ADDENDA / REVISIONS		NOT TO SCALE	BR 3-507 ON US113 OVER IRON BRANCH	CONTRACT	BRIDGE NO.	3-507	INDEX OF SHEETS	SECTION
				T201307301	DESIGNED BY:	JWK		BR
				COUNTY	CHECKED BY:	NED		SHEET NO.
				SUSSEX				2

**BR 3-507 ON US113
 OVER IRON BRANCH**

**ADDENDA AND
 REVISIONS**

CONSTRUCTION PHASING, M.O.T.
AND EROSION CONTROL PLAN
(SHEET 3 OF 4)

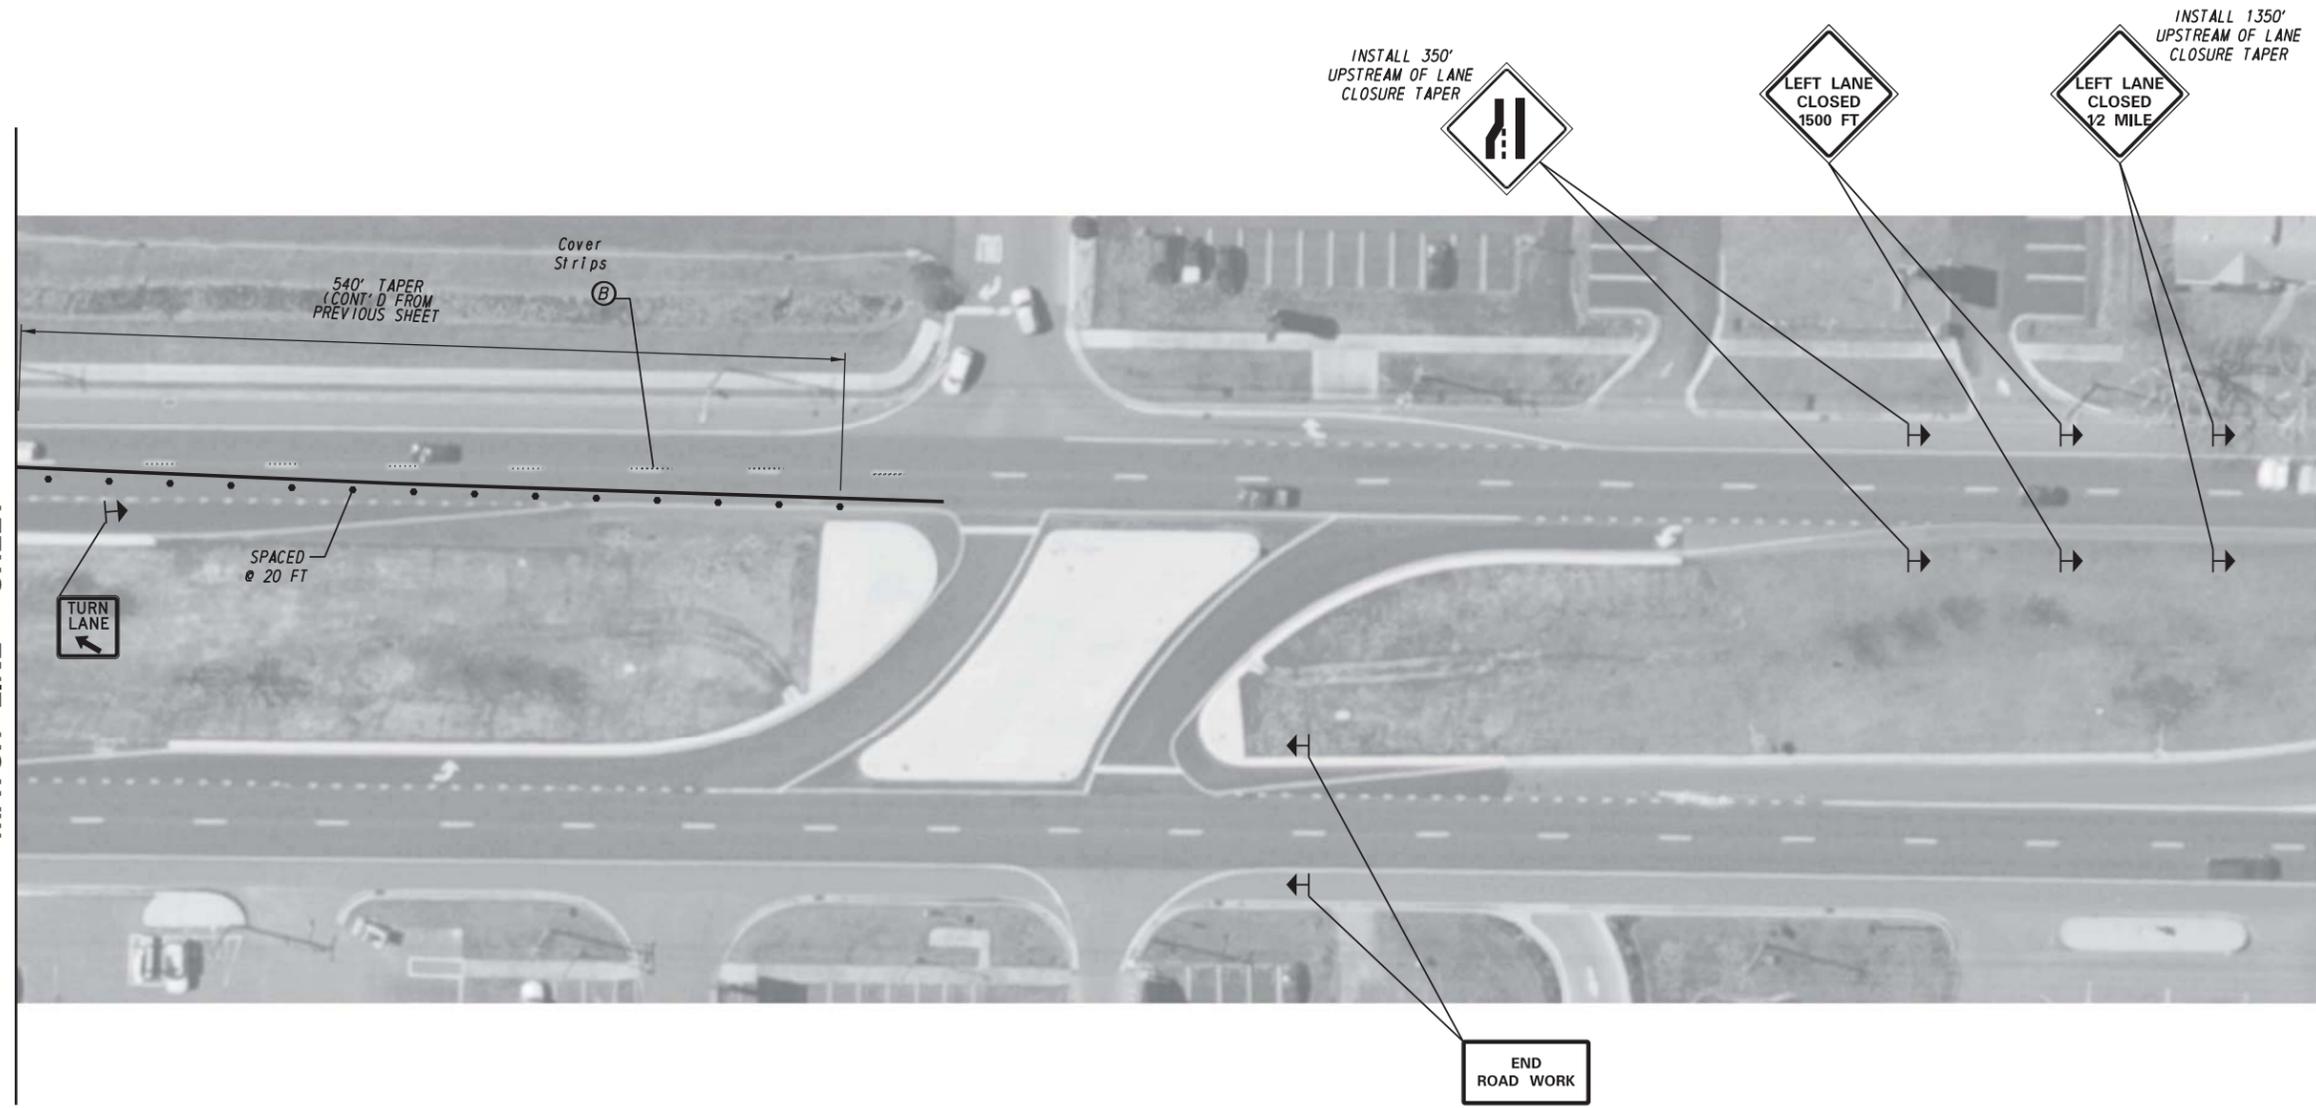
ADD NOTES:

1. ADD A VMS SB US 113, SOUTH OF SR 20

2. ADD A VMS ALONG SR 24
(USE PCMS 1 FROM TRUCK DETOUR PLAN)
